**MONTGOMERY COUNTY HISTORIC PRESERVATION COMMISSION**  
**STAFF REPORT**

<b>Address:</b>	7509 Carroll Ave., Takoma Park	<b>Meeting Date:</b>	08/16/17
<b>Resource:</b>	Contributing Resource <b>Takoma Park Historic District</b>	<b>Report Date:</b>	08/09/17
<b>Applicant:</b>	Gustavo Frech	<b>Public Notice:</b>	08/02/17
<b>Review:</b>	HAWP	<b>Tax Credit:</b>	Partial
<b>Case Number:</b>	31/06-17-CCC	<b>Staff:</b>	Dan Bruechert
<b>Proposal:</b>	Replace roof, doors, and other alterations

# PROPOSED WEST ELEVATION

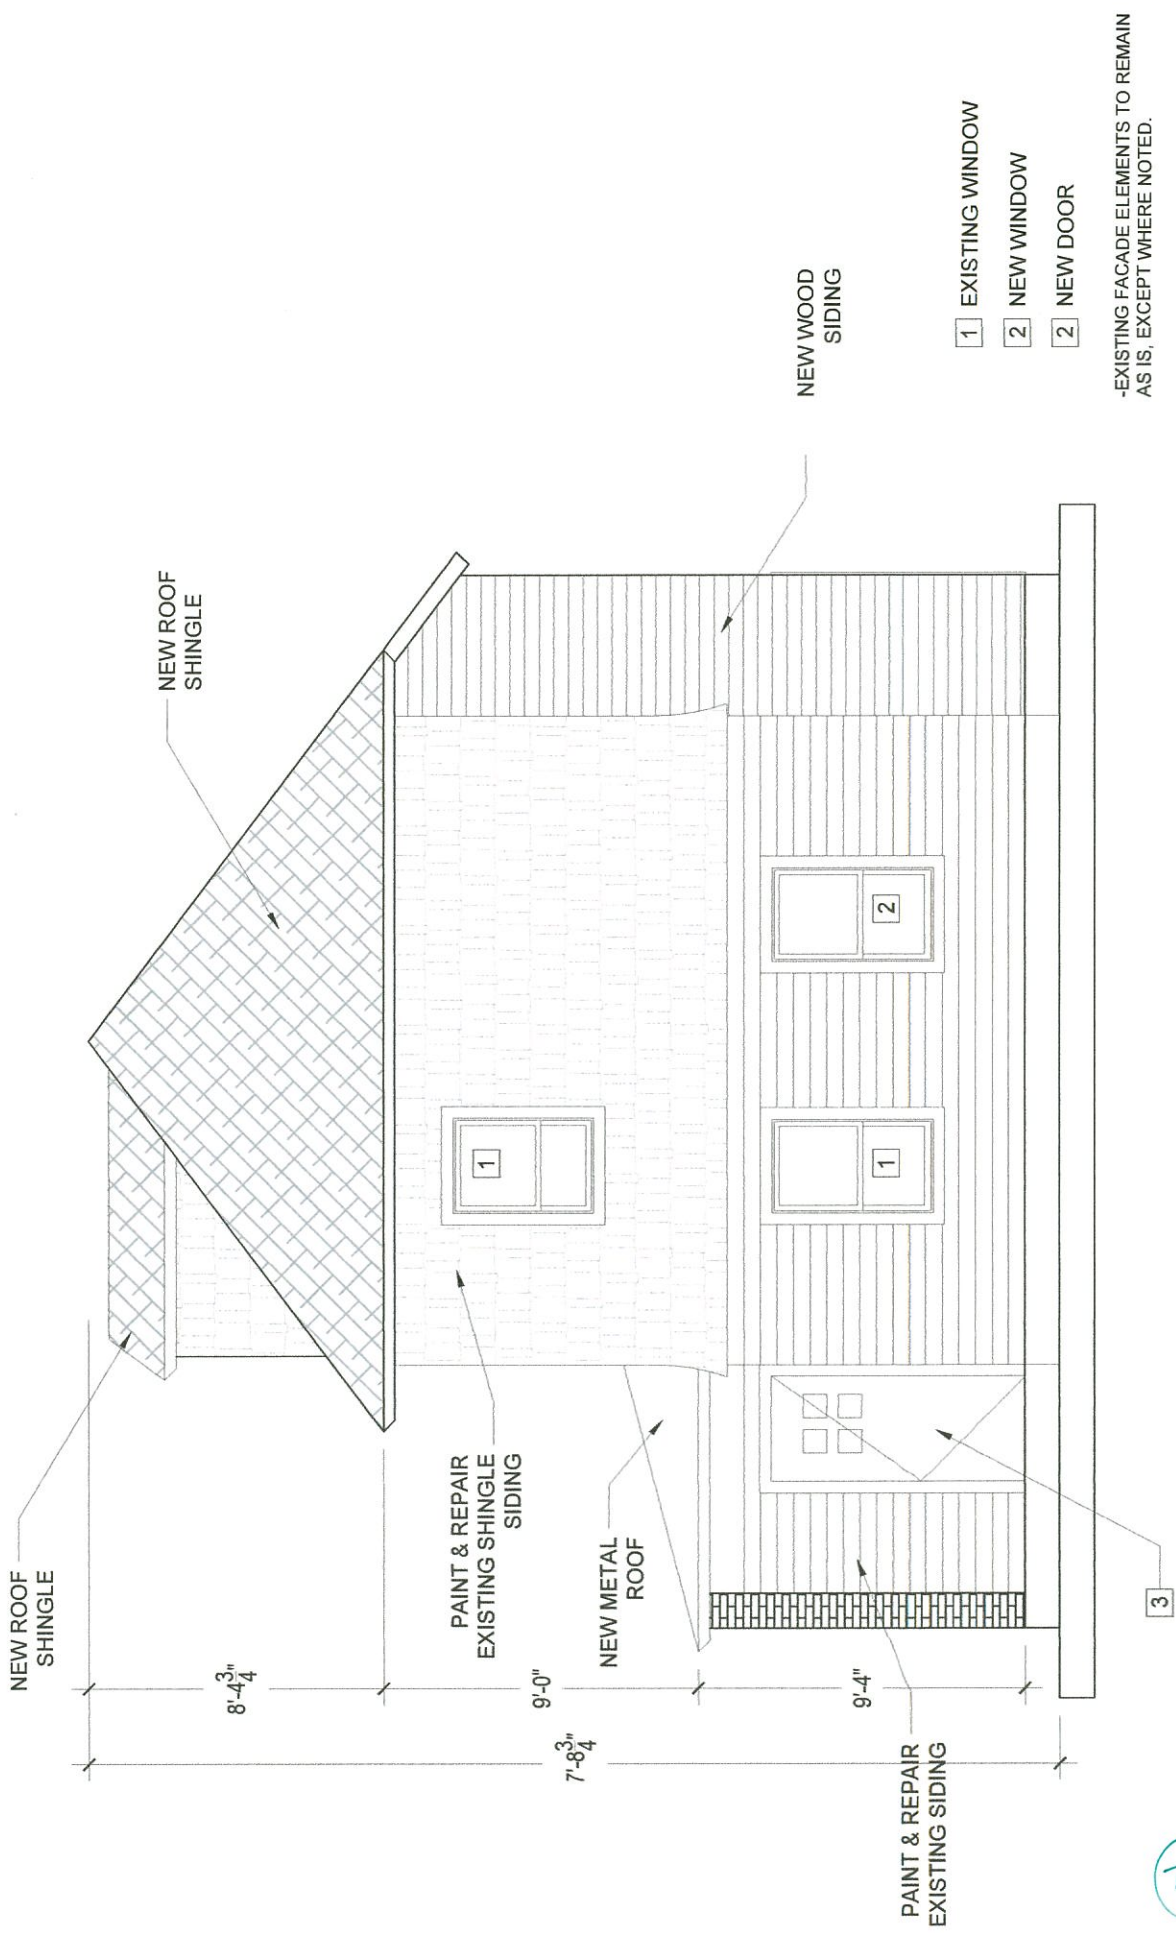
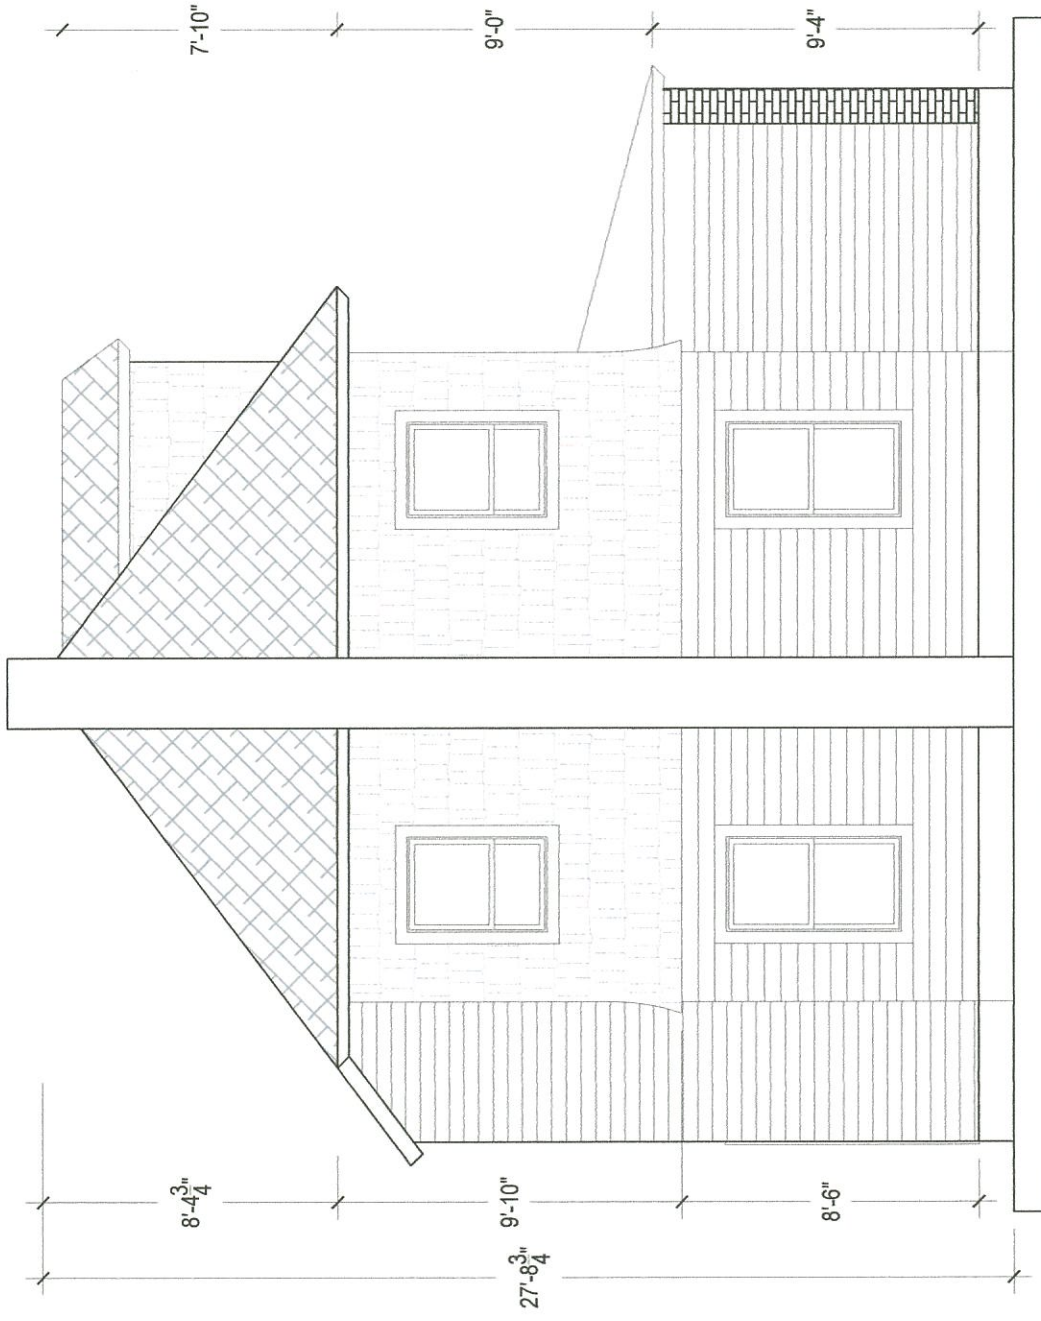
In conducting interior demolition, the applicant discovered there was a second opening on the first floor of the west façade. The applicant is proposing to re-open the window and install an Andersen 200 Series window in a one-over-one configuration to match the other windows in the house. The applicant is proposing to remove the historic 6-over-6 wood window. Staff believes that the historic 6-over-6 window should be repaired and retained in its current location. This window is on the first floor of the house near the front corner of the building and has a direct impact on the surrounding district. Additionally, this window is one of only three historic windows and the loss of historic fabric should be discouraged (per 24A-8(b)(1) and the Design Guidelines). Alternatively, the HPC could determine the wood window has degraded and that the desired uniformity of design will have less visual impact on the surrounding district than the combination of one-over-one and 6-over-6 windows.

The single second-story window on the west façade is a non-historic vinyl window. Removing this window and replacing it with the proposed is an acceptable treatment.

Finally, the applicant is proposing to remove the non-historic door on the west elevation and install a new door at the entrance to the front porch. The non-historic door does not add to the character of the house and its removal should be approved. The replacement door is a three-panel, Craftsman-style wood door with a lite. The Craftsman style is in keeping with some of the design elements of the house including the cedar shake siding and exposed roof rafter tails and should be approved.

PROPOSED EAST ELEVATION

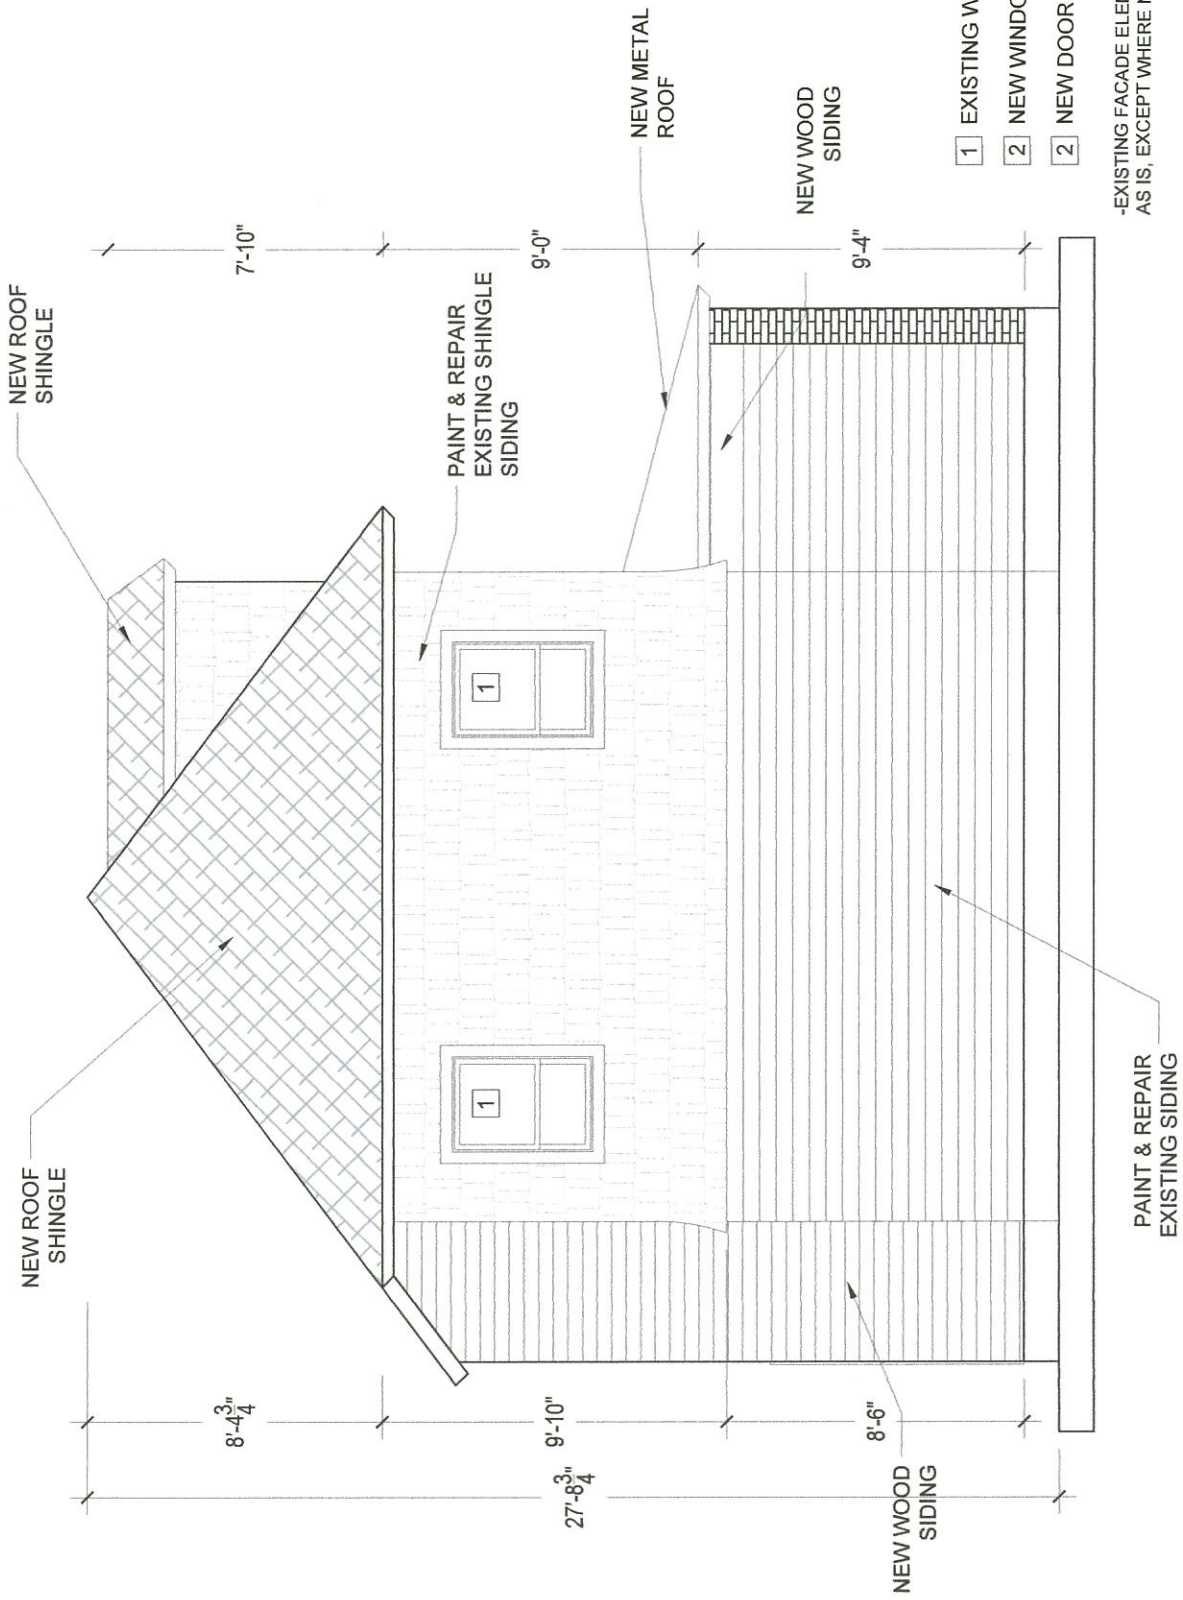
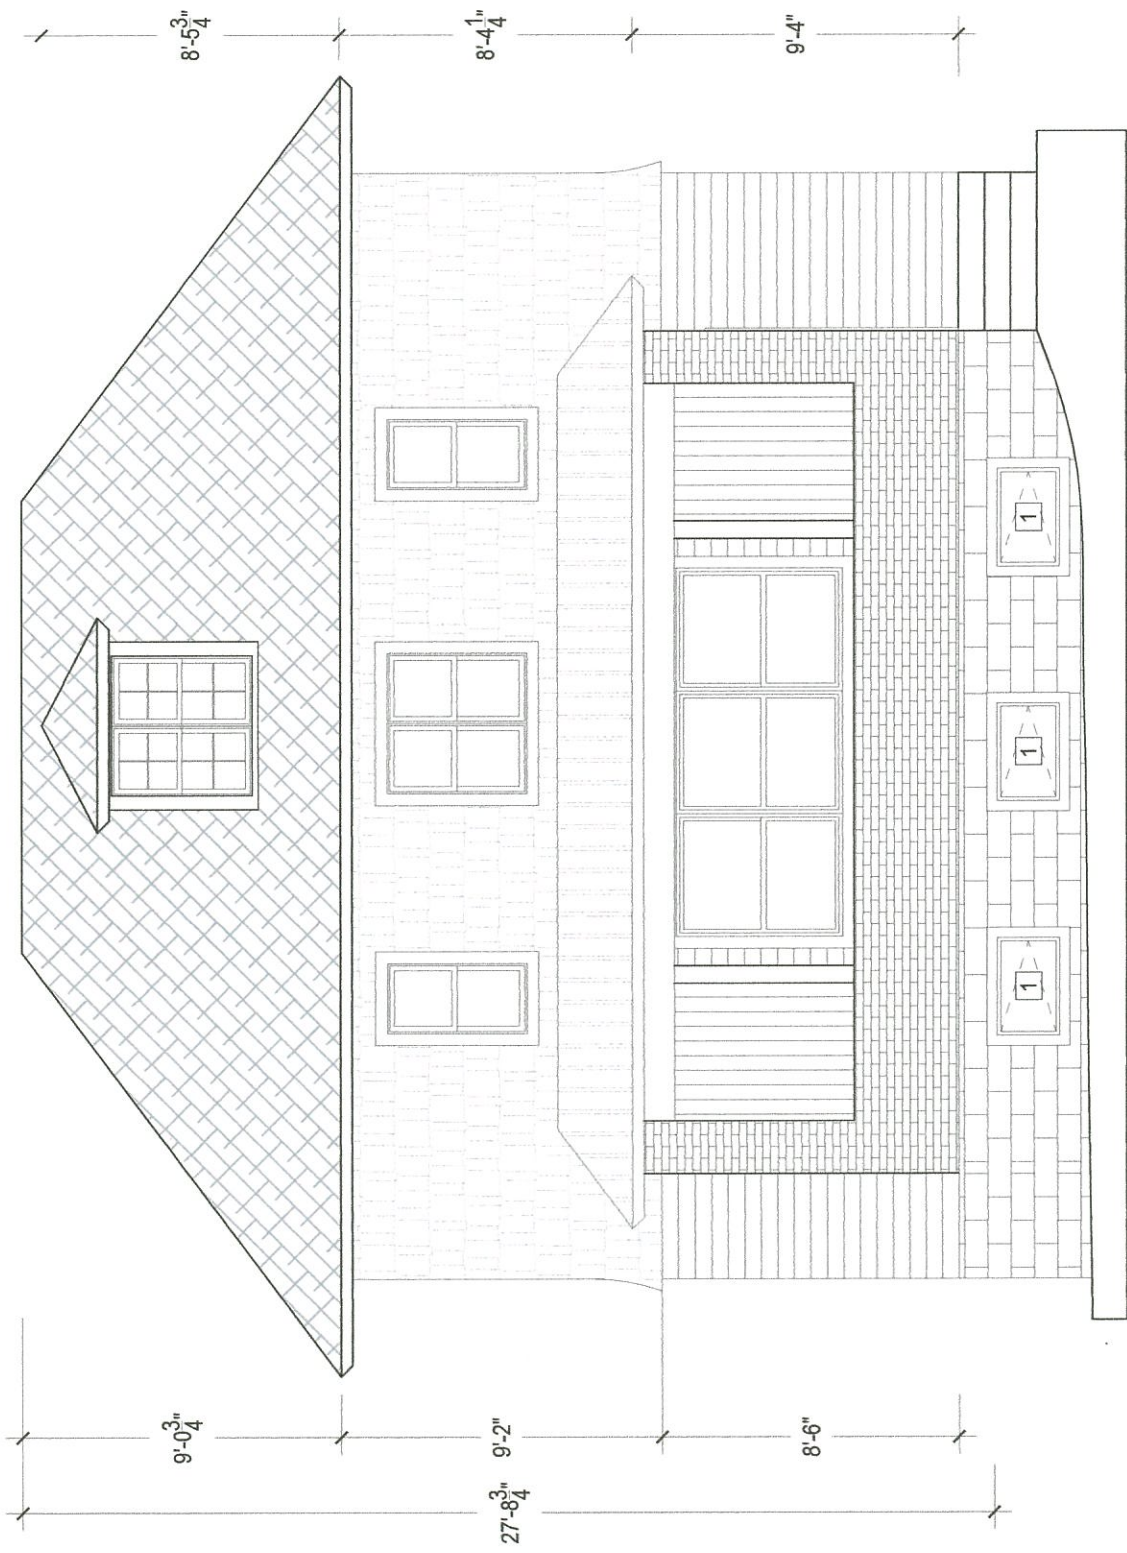
There is a parged chimney on the east elevation that the applicants would like to remove. The chimney appears to have been a later introduction to the house. This reasoning is based on the fact that the cedar siding is installed behind the chimney and there is a hole cut in the roof eave to accommodate the chimney extension.

Staff supports the removal of this chimney as it is non-functioning and non-historic; and does not add to the historic character of the surrounding district. The chimney's removal will not have a significant impact on the surrounding district. The chimney should be capped at or below grade so as to prevent water infiltration.

To accommodate the new interior plan for the house, the applicant is proposing to remove the two first-floor windows on the east elevation and cover them in clapboard siding. Design Guidelines state that the “original size and shape of the window and door openings should be maintained where feasible.” While Staff recognizes that this proposal stands in direct conflict with the Guidelines, Staff supports of this proposal. The subject building is placed at the minimum setback from the eastern lot line. And when this narrow setback is coupled with the close setback of the neighboring house, the east elevation is only minimally visible from the public right-of-way. Because of the minimal visibility to this façade, alterations to the east façade will only have a minimal impact on the surrounding district. However, the HPC may determine that this alteration has too significant an impact of the surrounding streetscape and that the applicant may need to retain one or both of the windows. The two second-story windows are non-historic replacement vinyl windows and their removal and replacement is acceptable under the Design Guidelines and Chapter 24A.
